SERVICE BULLETIN

TR-9130 Low Drive Level

7-05-83

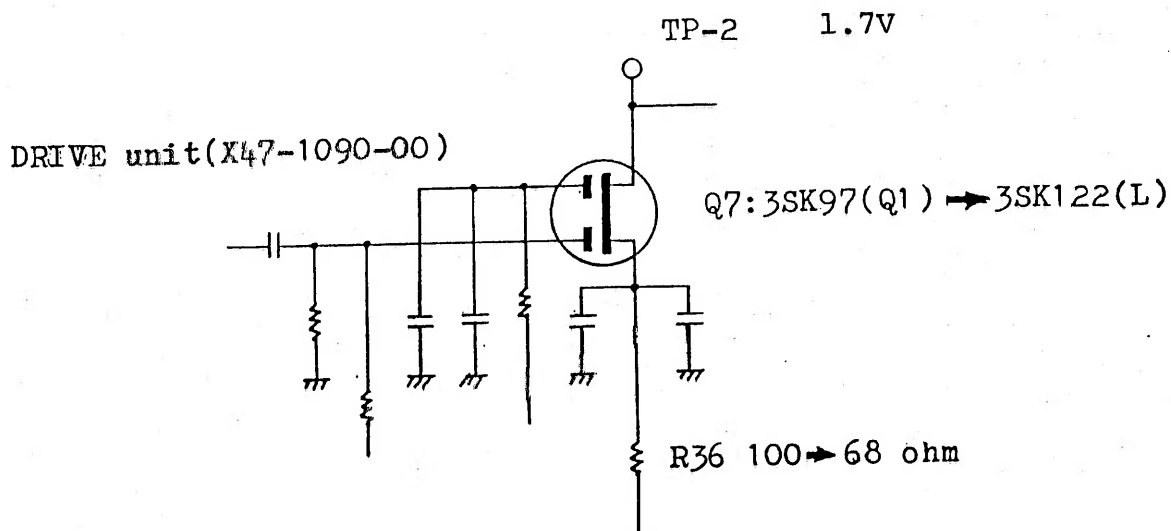
For reported cases of low transmit power output check the level of the TX driver transistor Q7 of the DRIVE unit (X47-1090-00). If the TX drive level is low make the following changes.

Old Part

Q7: 3SK97 (Q1)
R36: 100Ω

New Part

3SK122(L)
68Ω (RD14BB2E680J)
